**Comments on Responses
Submitted for Deadline 3**
on Behalf of the
**Neighbours and Users of
Queen Elizabeth Park**

Interested Party reference no: **20022545**

1. General Arrangement Plans (3 of 3)¹

1.3. Location of Notable Trees

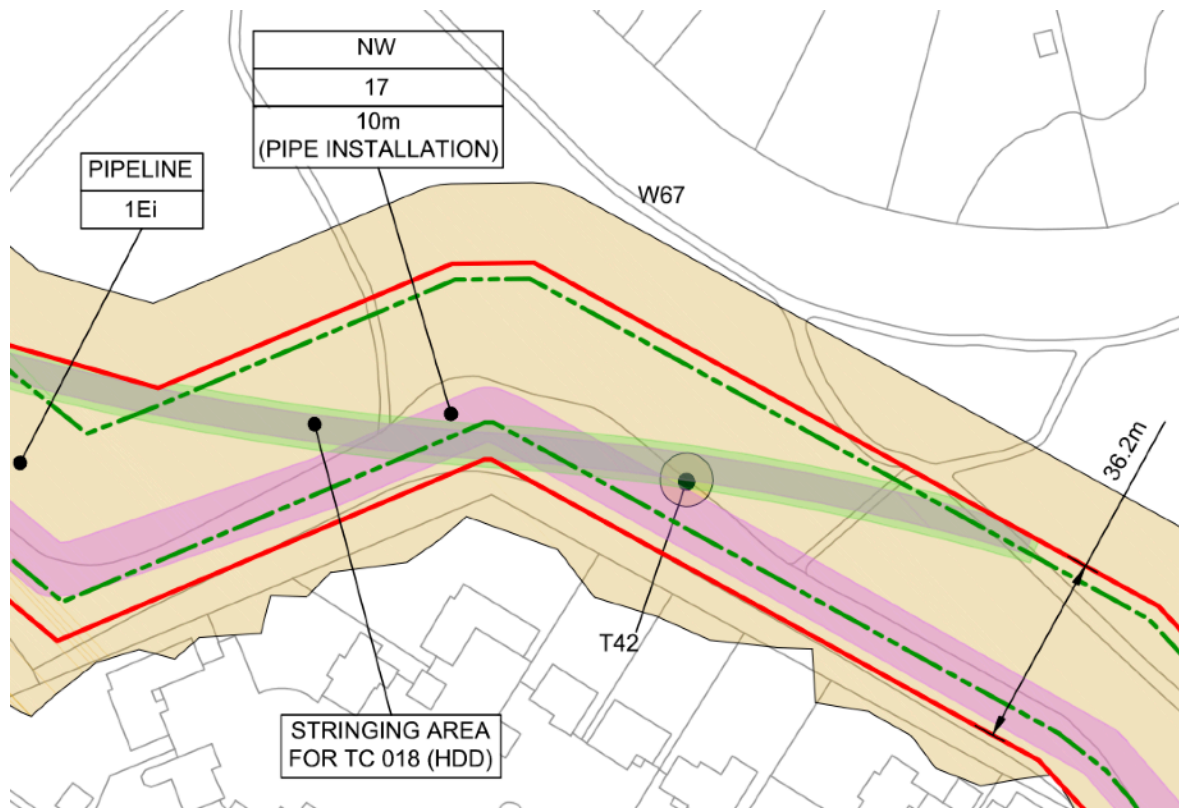
Action point 9 from ISH3 asks for the location of notable trees to be shown on the General Arrangement Plans. Esso have responded to this by shading entire areas of the park in beige.

1. This is not satisfactory because it does not show how individual trees might be affected by the working areas (this would have been known when providing the response to action point 7 from ISH 2).
2. Trees which were listed on the Woodland Trust's Ancient Tree Inventory at the time the plans were produced should have been included.
3. Preliminary results of Esso's tree survey would also have been available (these even seem to be shown in Figure 1.4 on page 72 of Esso's Responses to Written Representations - Other Parties).

The plans do not make best use of the information available at the time they were produced.

We understand that Esso's tree survey must be submitted at Deadline 4, so we expect the next revision of the General Arrangement Plans to show the required details.

1.5. Drill and Receptor Pits

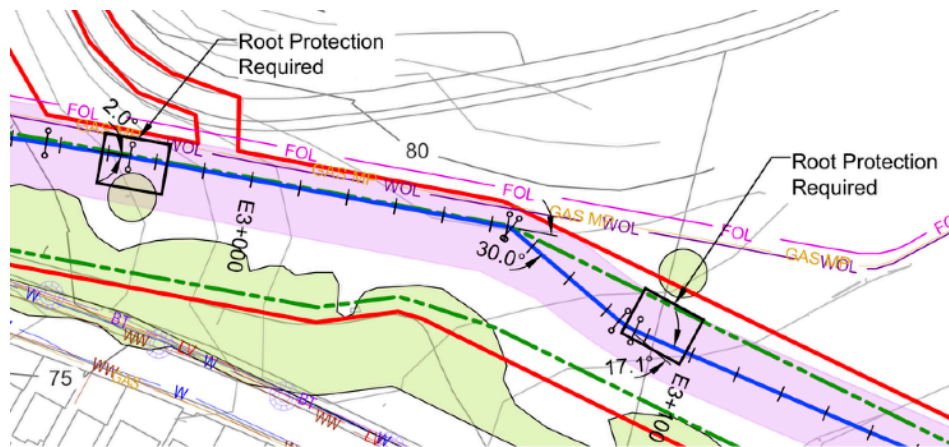
Action point 9 from ISH3³ asked for the location of drill and receptor pits to be shown for narrow working areas and streets. Esso's summary of oral submissions at ISH3⁴ also records this request and commits to showing drill and receptor pits along the entire route (item 3.1.3).

1. No drill or receptor pits are shown within Queen Elizabeth Park.
2. We realise that these pits are not themselves within a narrow working area but they are in a known hotspot and they directly adjoin a narrow working area.

No such areas are shown next to the two individually indicated trees (T41 and T42) in Queen Elizabeth Park on sheet 89:

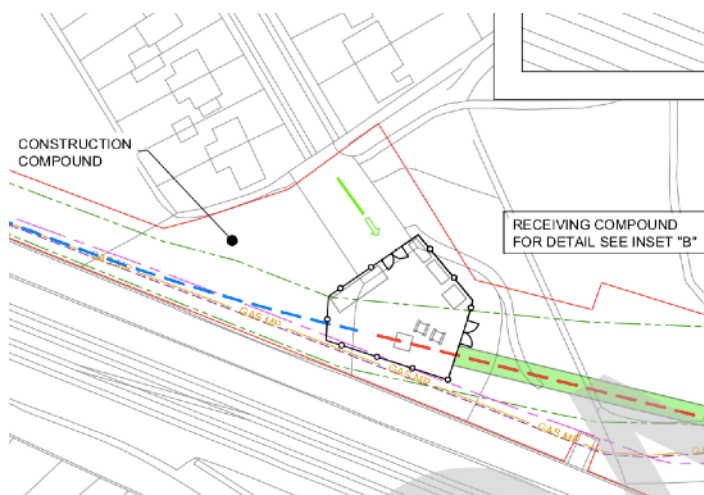
T41 is the circle at the centre of the extract on the left, T42 is the circle in the same position on the right.

1. There seem to be no plans to protect the root areas of T41 and T42.
2. There are no plans to protect root areas of any other trees in the park.

3.1. Tree T41

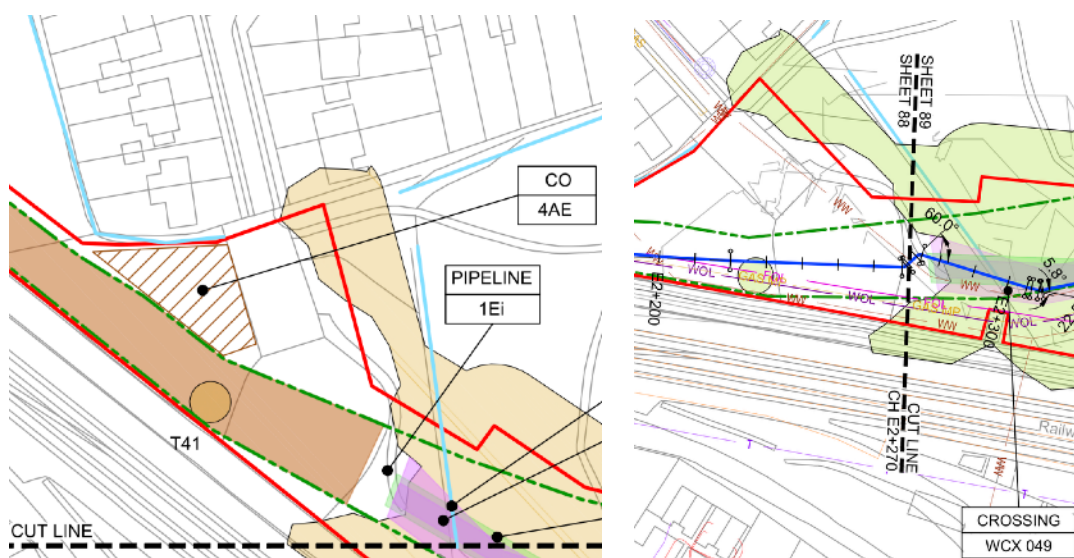
The drawing for TC018 omits Tree T41. This is a notable tree from Esso's list which is near the Queen Elizabeth Park play area. It is situated within the HDD limits of deviation.

T41 is shown in the General Arrangement Plans on sheet 105 (below left) and in the Alignment Sheets (narrow working) on sheet 89 (below right).

This tree is also absent from the longitudinal section (A-A) of the TC018 drawing.

1. T41 is in the section where the bore rises to enter the reception pit and therefore it is at risk of root damage.

2. The works are within the root protection area of the tree.
3. As a minimum, Esso's Technical Note on Ancient Woodland and Veteran Trees commits to mitigation B3, specialist techniques, e.g. hand digging.
4. Hand digging within a tree's root protection zone is the most invasive of the three mitigation categories. However, in this case, a rising HDD bore is being driven through the root zone, which is far more invasive and destructive.

4.8. Page 73, WR Paragraph 2.6.2: Auger Boring Compound

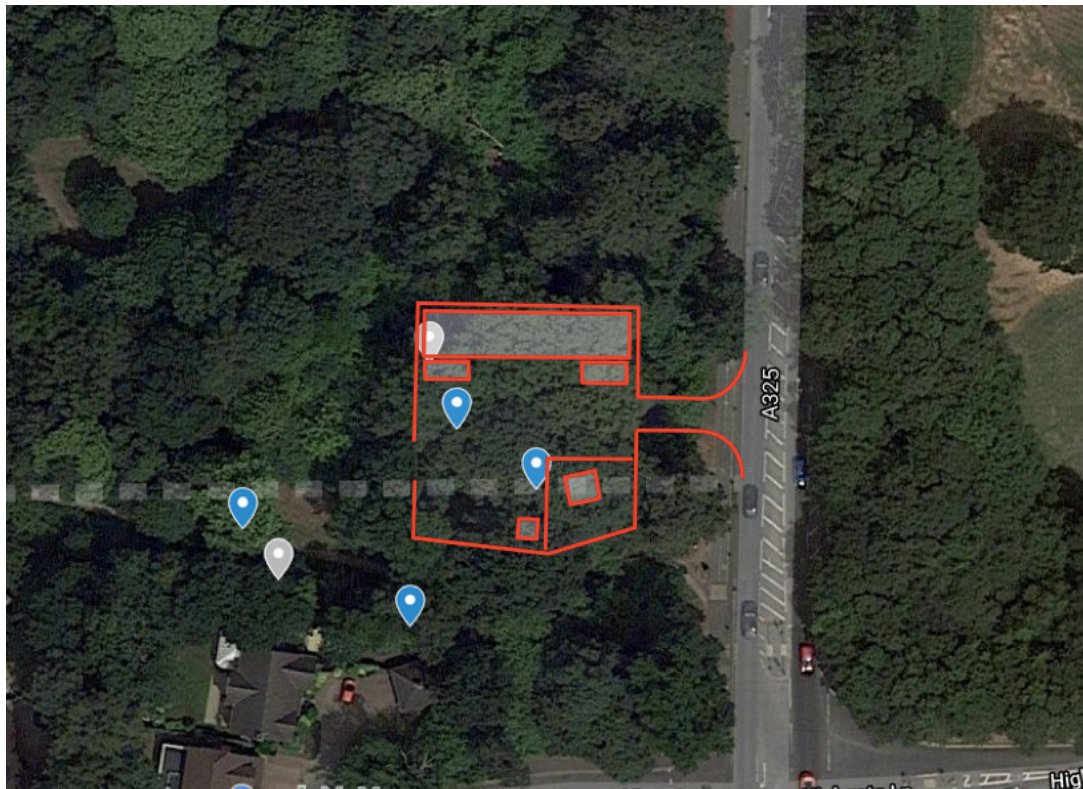
This ignores root protection zones. We would also be very interested to know which equipment Esso plans to position **in** the trees. We are unable to think of any construction equipment which would benefit from such placement, and are concerned about the potential damage it could cause to the trees.

The comments about the anticipated extent of tree removal are contradicted in Esso's response to paragraph 2.4.1 on page 63: *'The area for the trenchless crossing of the A325 will require greater tree removal in comparison [to the narrow working area].'*

By overlaying Esso's diagram from Figure 1.5 on an aerial view of the park, it is easy to see that significant tree removal will be required, including two notable trees (marked in blue). Even if all trees are retained there will be major disruption in their root protection zones.

(The grey dotted line is Google Maps' representation of the footpath. This does not represent the true position of the footpath: it does not run through the proposed compound.)

With the layout shown above, it does not seem to be feasible to operate the working area in a satisfactory manner without removing trees. For example, one of the notable trees will prevent the backhoe/excavator from rotating anti-clockwise from the reception pit to unload its bucket into a wheeled dumper for transport to the topsoil stockpile. It is difficult to envisage a safe, working compound with the trees still in place.

4.8.2. New Compound

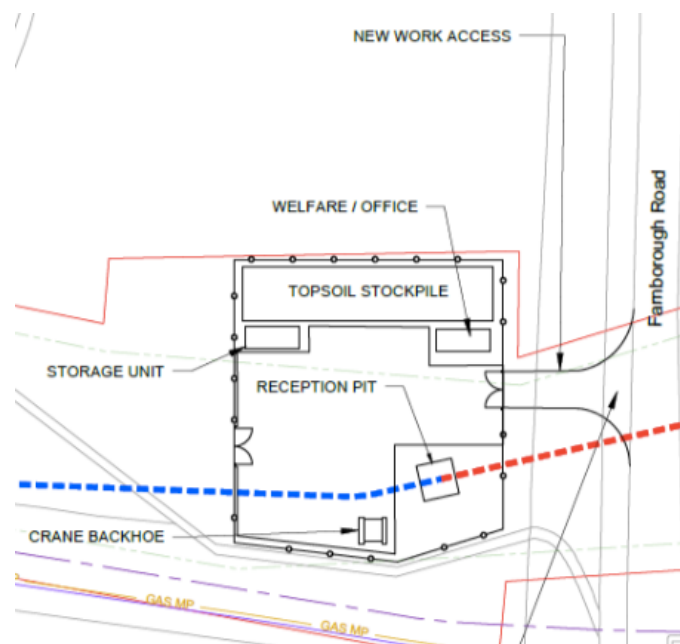
The structure shown in Esso's Figure 1.5 shows that the previously proposed auger boring pit has now grown to become an additional compound in the park, with storage and welfare facilities.

1. Until Deadline 3, Esso's plans had indicated that only one compound would be present in the park. Now, with the addition of this compound and the one around the Stake Lane reception pit, there are three compounds.
2. No generator is shown yet this compound contains a welfare/office facility.
3. The possible presence of a generator - and its location - are particularly pertinent details due to the close proximity of this compound to number 25 Queen Victoria Court.

Esso's Figure 1.5 shows gates which provide access from the compound into the park. These gates should not be necessary because Esso have stated on page 75, in response to paragraph 2.6.2, that:

1. The intended purpose of the gates in the western side of the compound
2. What will be brought in and out of the park via the compound?

Appendix 2 of Esso's document shows the location of Veteran Trees and potential Veteran Trees. Sheet 103 covers Queen Elizabeth Park.

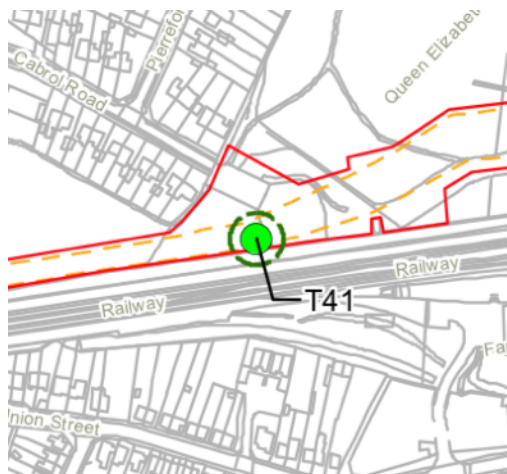
The notes on this sheet state that Veteran Trees which were in the Woodland Trust database (Ancient Tree Inventory) as of 29th August 2019 are shown. Potential Veteran Trees identified by Esso are also shown.

1. Only one potential Veteran Tree is shown in Queen Elizabeth Park: Esso's T41. T42 is missing, even though it was identified by Esso during their survey. We question why this has been omitted.
2. The Limits of Deviation run straight through the indicated buffer zone of T41. T41's buffer zone also intersects with the proposed Cabrol Road construction compound and the proposed Stake Lane HDD reception pit compound.

Esso's Figure 1.1 (reproduced below) shows three compounds in the park (circled):

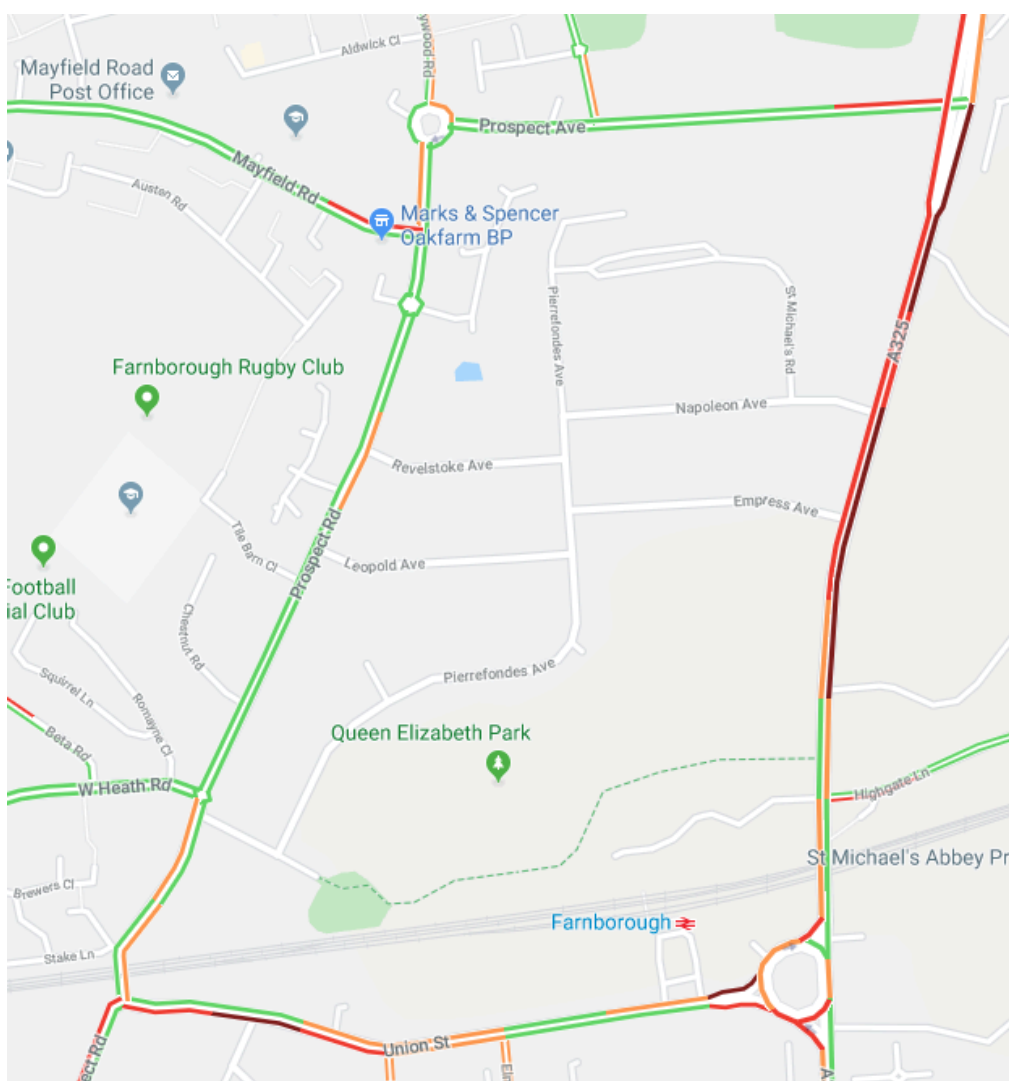
We believe that the leftmost compound on the plan, indicated by the hatched area, is identified as Work No. 4AE in the dDCO.

Two additional compounds are shown, which were previously referred to as drill pits, for example, in Esso's Queen Elizabeth Park Information Sheet¹⁷. As the plans in Esso's Figure 1.1 show, these drill pits are now compounds and contain far more extensive facilities than originally indicated.
